From: Jill Bastow
Sent: 20 April 2016 14:20
To: Planning
Subject: FW: NYM/2016/0168/FL Seascape, Robin Hoods Bay
Attachments: SKS 04A.pdf

PROJECT
 REPLACEMENT FRONT DORMER WINDOWS, NEW
 REAR ROOF TERRACE AND GARDEN RAILINGS
 for
 Mr & Mrs MURPHY
 at
 SEASCAPE, KING STREET, ROBIN HOODS BAY

TITLE
 Notes
 PROPOSED ELEVATIONS

SCALE	DATE	DRAWING No	REVISION
1:100 @A3	Feb 2016	SKS 04	A

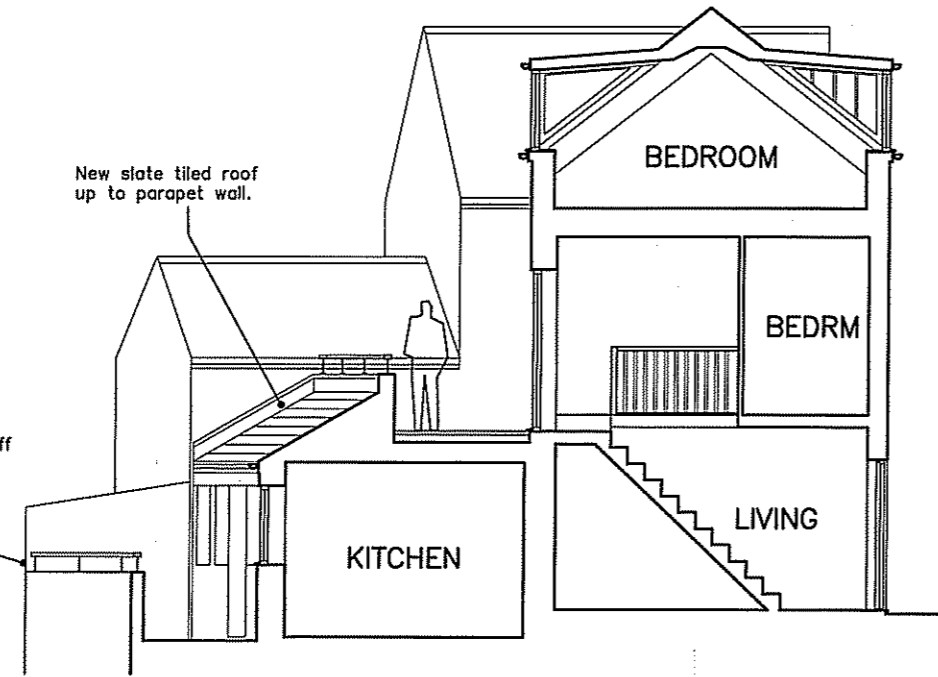
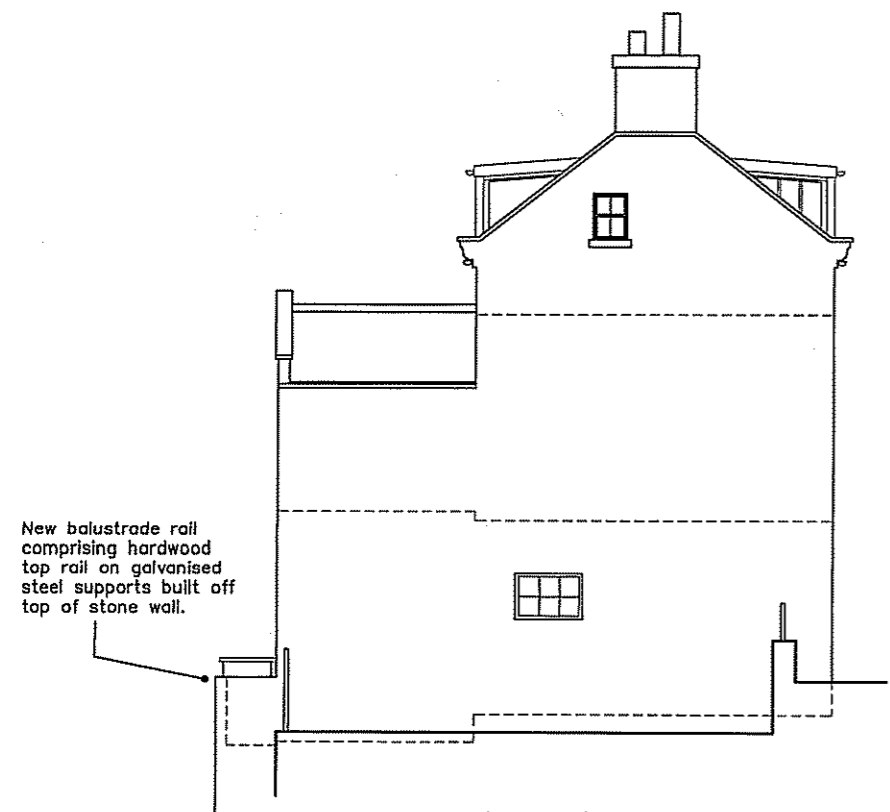
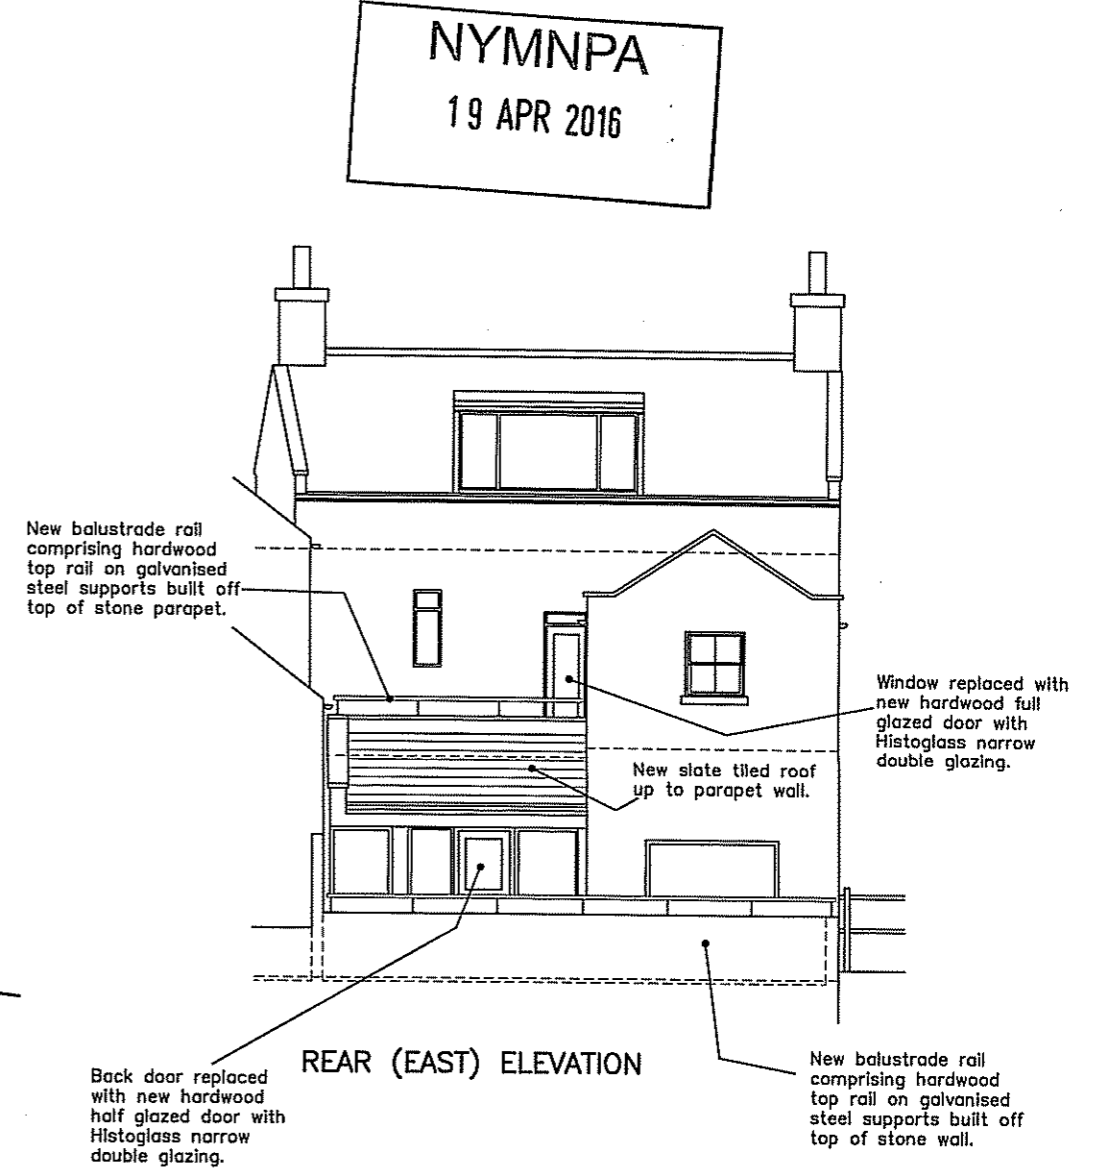
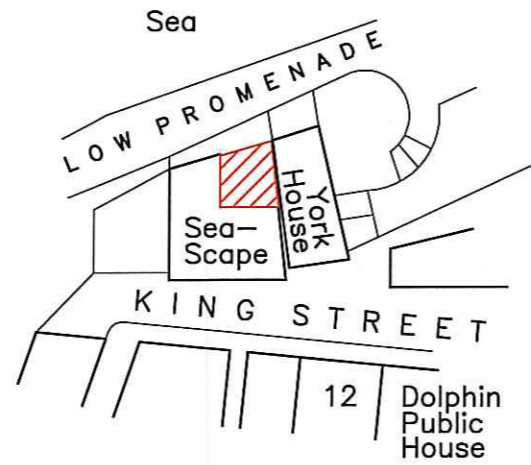
Many thanks for the amended plans Rob. However before I send them off for re-consultation I note that the proposed glass balustrade to the patio is still shown on the elevation drawing. I would be grateful if you could let me have a duly amended plan at your earliest convenience showing the proposed stone boundary wall and timber rail.

The glass and stainless steel balustrading has been removed from the scheme. The roof terrace has been reduced in size and pulled back from the edge of the kitchen roof to avoid any overlooking. The roof terrace is now to be hidden behind a slate tiled mansard roof to the kitchen with a stone parapet wall with a hardwood rail to the top supported on short galvanised steel posts/brackets. There is to be a stone upstand to the open edge of the tiling with a stone capping to reflect the main house roof.

The boundary wall to the patio has also had the glass and stainless steel balustrading removed, to be replaced by a stone wall with the same timber rail with galvanised support brackets on top. The existing wall needs to be raised in height as it is currently too low and dangerous and the timber rail will deter anyone from sitting on top of the wall which is also dangerous as there is a drop the other side.

A. ROOF TERRACE AND BOUNDARY WALL ALTERED. 18.04.2016
